DETERMINATION AND STATEMENT OF REASONS

SYDNEY WESTERN CITY PLANNING PANEL

PPSSWC-337 – Fairfield – DA 167.1/2023 - 84 Broomfield Street, Cabramatta – Demolition of existing buildings and staged (Stages 1 and 2) construction of a mixed-use development up to 19 storeys comprising basement carparking over which will be a new market square, three (3) buildings containing ground level retail and a tavern, first floor commercial and a restaurant as well as 358 apartments above. The DA also includes public domain improvement and associated stormwater works.

Figure 4 - Current and potential development of Broomfield Street isolated sites

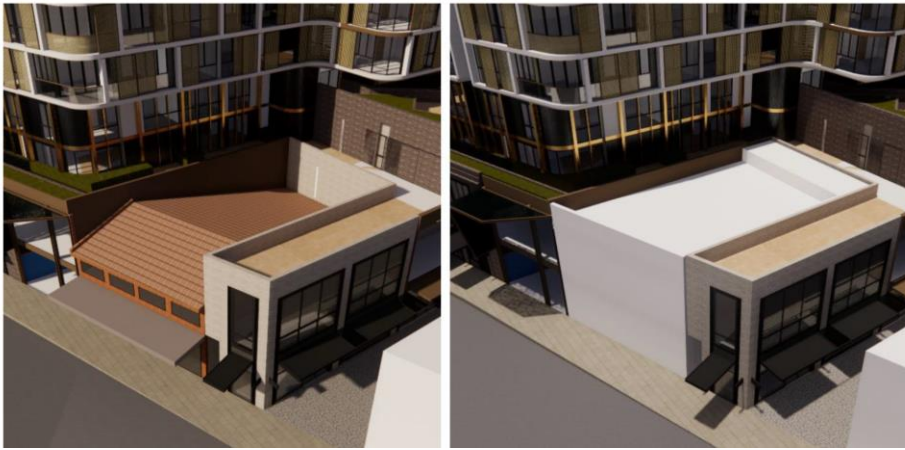
There are similar concerns over the nil setback proposed to the isolated sites on Broomfield Street and Cabramatta Road East which appears to assume that the site will only ever be redeveloped to its existing 2 storeys (assuming commercial floor to ceiling heights). These images from the original plan package show how the DA design has assumed a maximum height for future development of both isolated sites of two storeys.

Figure 6 - Level 2

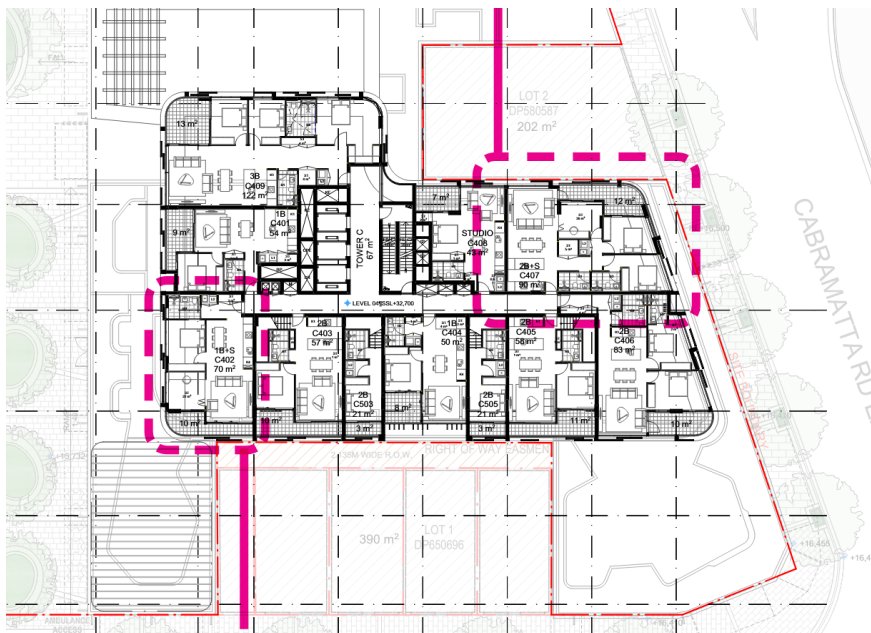
While the latest plans allow a setback to the isolated sites to 4 storeys, if those sites are developed to that height then the undercroft will be essentially walled in as tunnels. Apartments C209 and C203 - C205 for example would have no natural light at all if the isolated sites rose above the podium floor level. This can be observed from the details below from the “Laneway Feasibility Study” plan set:

Fig. 4 – Proposed Building Envelopes

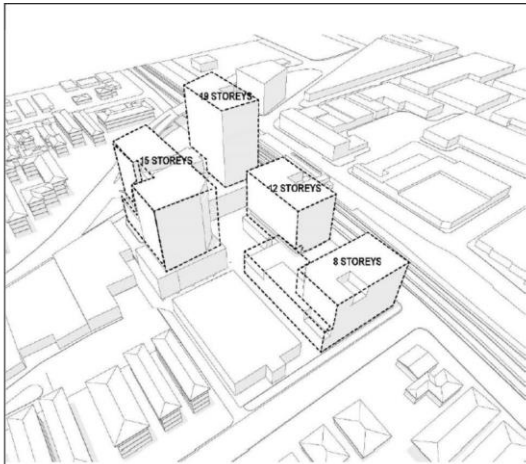
The 'proposed building envelopes' and 'height and siting of building envelopes' diagrams below (again presumably authored by the rezoning proponent) are included in the precinct specific portions of the DCP at Figures 4 and 5.

The 12 storey element in the location of what is now proposed as Building B has become 16 storeys in the new scheme. Building A which was to be a maximum of 15 storeys, but with a lower 14 storey element to allow a transition to the Stage 3 building has become in the revised proposal 16 storeys without any transition element. The 7 storey element on Cabramatta Road East would now be impossible because of the design choices fronting the isolated site discussed above.

Fig. 5 – Heights and siting of building envelopes

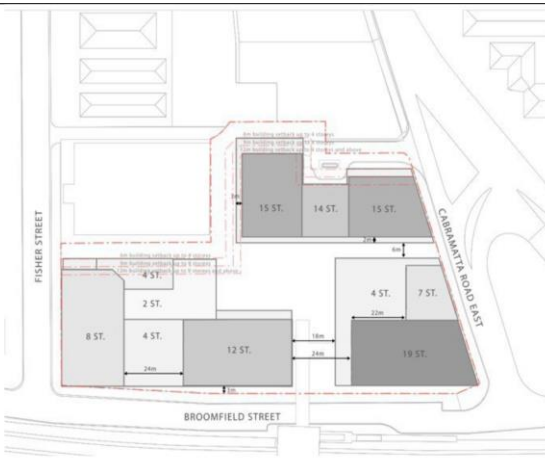
The additional height of Building B would have consequences for the solar impacts upon the public square, but the Panel has not attempted to determine whether they would be acceptable.
